Subject: Transmittal of Revision 4 to Service Bulletin V2500-ENG-73-0130.

(1) Change to Effectivity, Incorporation Amendment.

V2500-ENG-73-0130

ENGINE - FUEL AND CONTROL - FUEL SYSTEM AIR TUBES - INTRODUCTION OF REVISED PB
SENSE LINE TUBES WITH INCREASED DIAMETER

Figure 36
Clip point 2692 and 2693 - Added

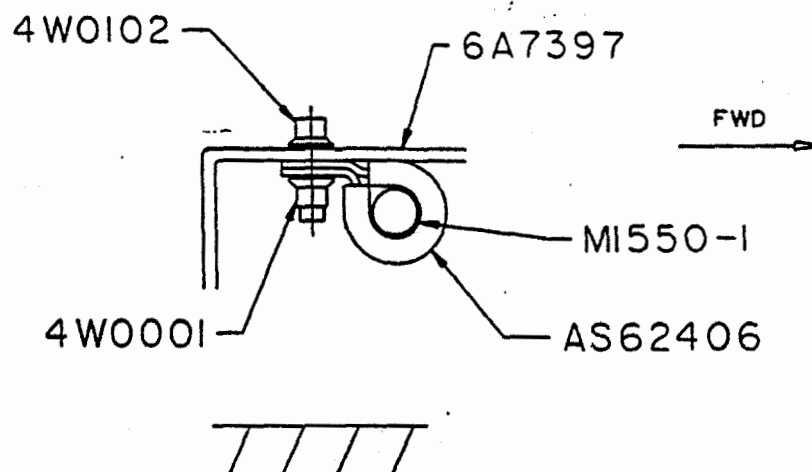
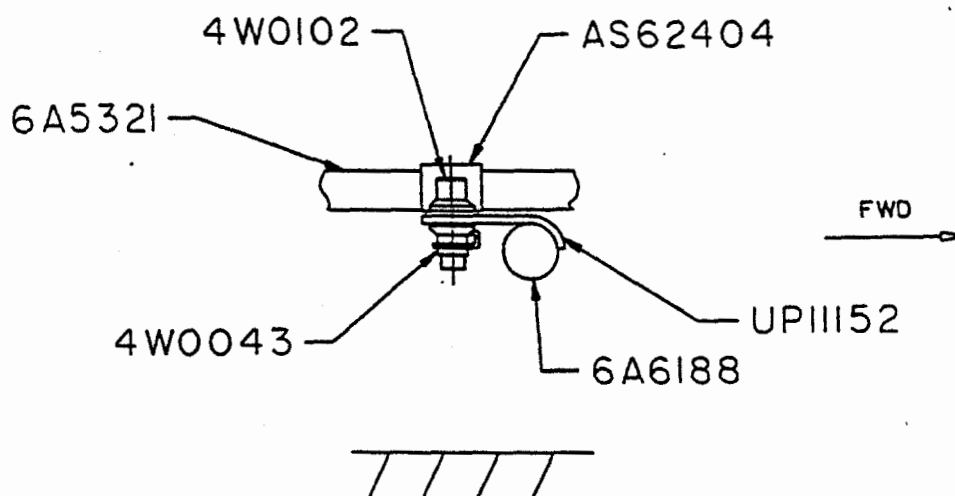
- (i) Install clip AS62406 to M1550-1.
 - (ii) With bolt 4W0102, washer K8831 and nut 4W0001, install CP2691 to bracket 6A5429.
- (g) Connect M1550-1 to CP2692. (Refer to Figure 36).

- (i) Install clip AS62406 to M1550-1.
 - (ii) With bolt 4W0102 and nut 4W0001, install CP2692 to bracket 6A7397. (Refer to Figure 3).
- (4) Install tube 6A6186. (Refer to Figures 5, 6, 7, 11, 12, 34 and 35).

- (a) Install CP2693. (Refer to Figure 36).
 - (i) Install clip AS62404 to tube 6A5321 adjacent to the brazed-on clip UP11152 of tube 6A6188.
 - (ii) Connect the clips together with the bolt 4W0102 and the nut 4W0043.

Figure 37
Clip point 2694 - Added

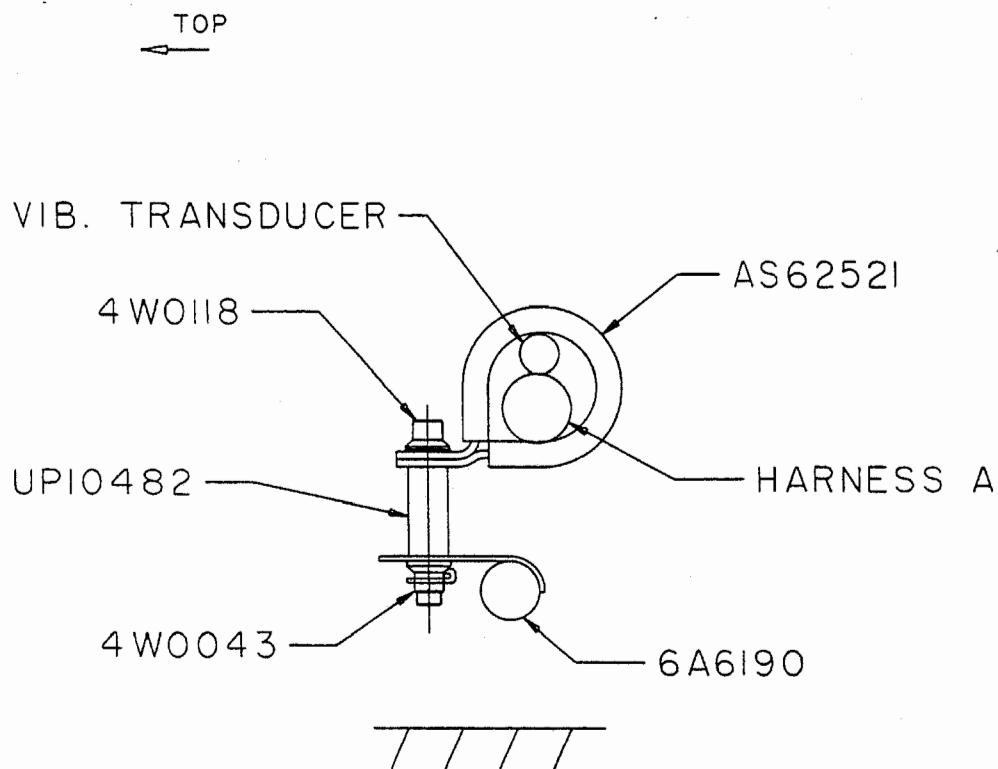
- (iii) With the bolt 4W0115, the spacer UP10481 and the initial nut, install CP2198. (Refer to Figure 25)
- (b) Install CP2694 to 6A6190, Harness A and the vibration transducer loom. (Refer to Figure 37).

Figure 38

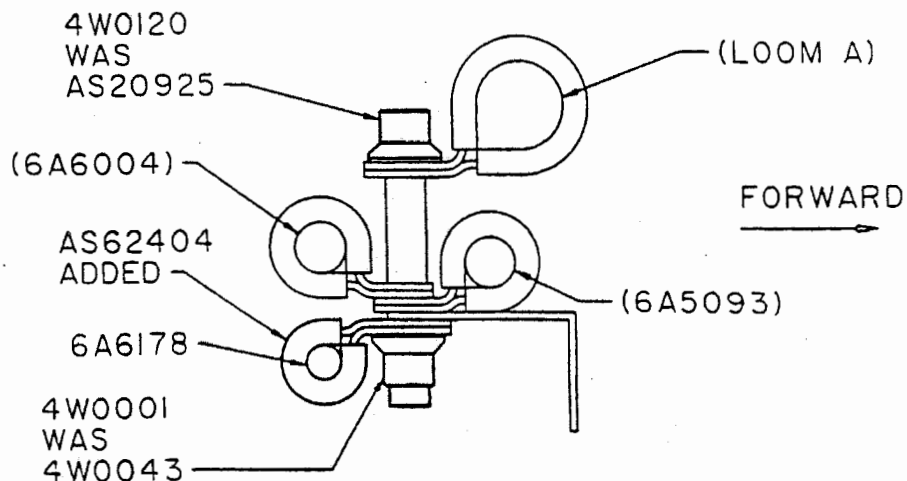
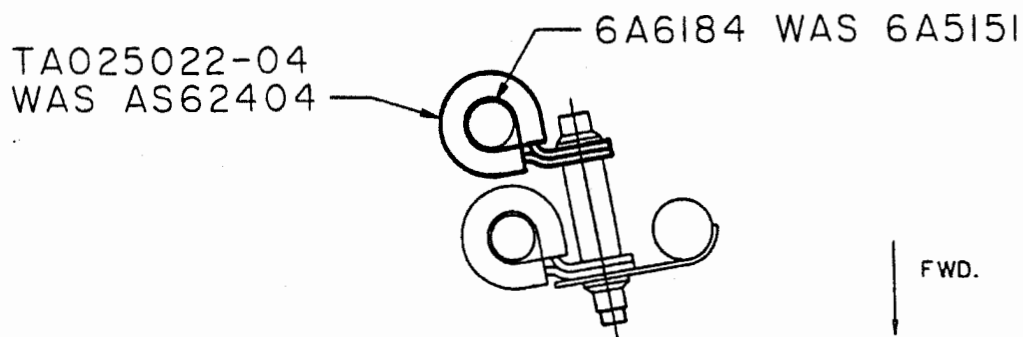
- (d) Remove and discard the tube.
- (10) Remove the tube 6A5151. (Refer to Figure 4 and 38).
 - (a) Disconnect tube 6A5151 from CP7066. (Refer to Figure 38).

- (b) For engines at Service Bulletin ENG 73-0105 standard, connect tube 6A6188 to CP2038. (Refer to Figure 5).
 - (c) For engines not at Service Bulletin ENG 73-0105 standard: with clip AS62404, bolt 4W0120 and nut 4W0001, connect tube 6A6188 to CP2038. (Refer to Figure 4 and 38).

- (b) Connect tube 6A6184 to CP7066. (Refer to Figure 38).
 - (c) Connect tube 6A6184 to the clip points that follow: CP7074, CP8034, CP7092, CP8033, CP8032, CP7073 and CP7834.

Figure 40
Clipping bracket 6A7396 - Before and after rework

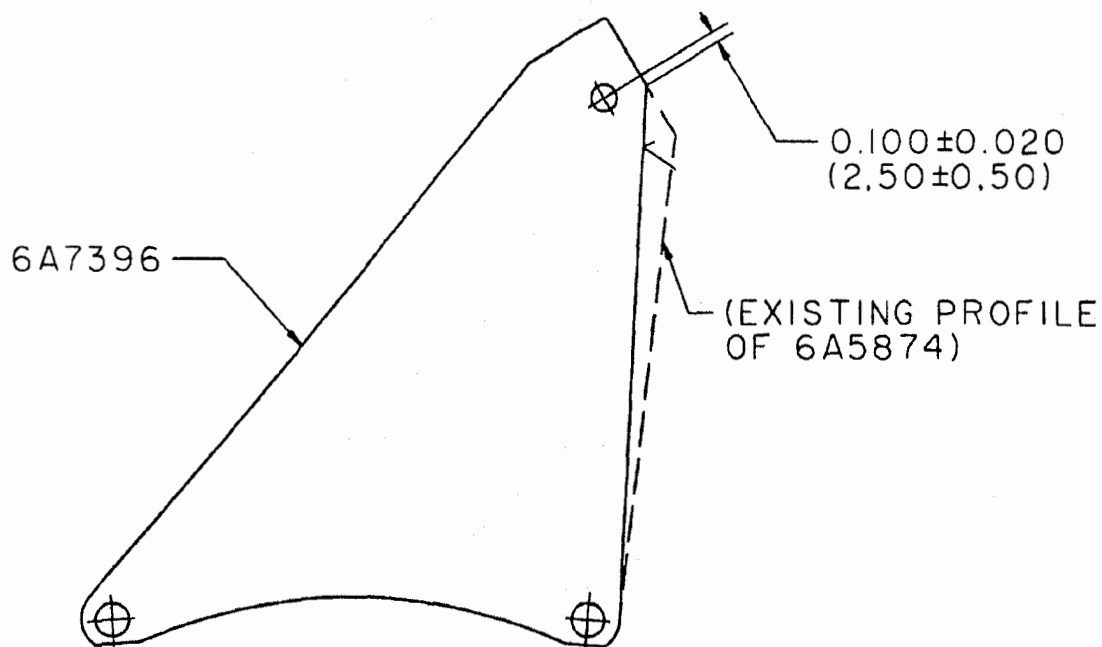
A. Rework bracket 6A5874 (71-51-51, Fig/Item 05-320), to make bracket 6A7396. (Refer to Figure 40).

(4) Mark-off the area of the clipping bracket to be removed. (Refer to Figure 40).

(5) Rework the clipping bracket in the area shown. (Refer to Figure 40).

(6) Remove sharp edges. (Refer to Figure 40).

(9) Visually examine and measure the dimensions of the reworked area. (Refer to Figure 40).

Figure 41
Clipping bracket 6A7397 - After rework

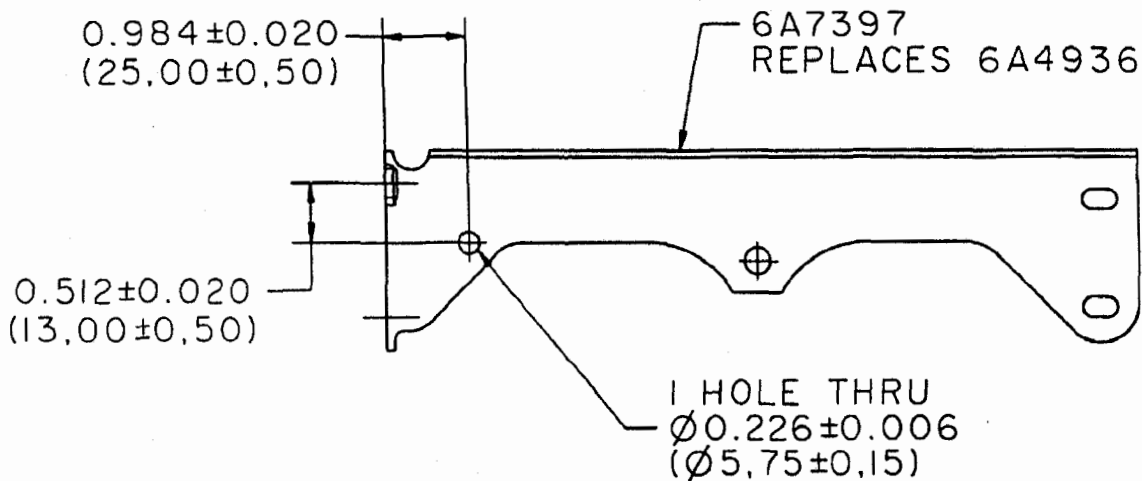
B. Rework bracket 6A4936 (73-22-59, Fig/Item 08-671), to make bracket 6A7397. (Refer to Figure 41).

- (a) Mark the position of the hole with a centre punch. (Refer to Figure 41).

- (5) Remove sharp edges and burrs from around the hole. (Refer to Figure 41).
 - (a) Use standard workshop equipment.
- (6) Chemically clean the clipping bracket.

- (i) If cracks are found, reject the bracket.
- (9) Visually examine and measure the dimensions of the reworked area. (Refer to Figure 41).
- (11) Delete the initial part number and identify with the new part number.
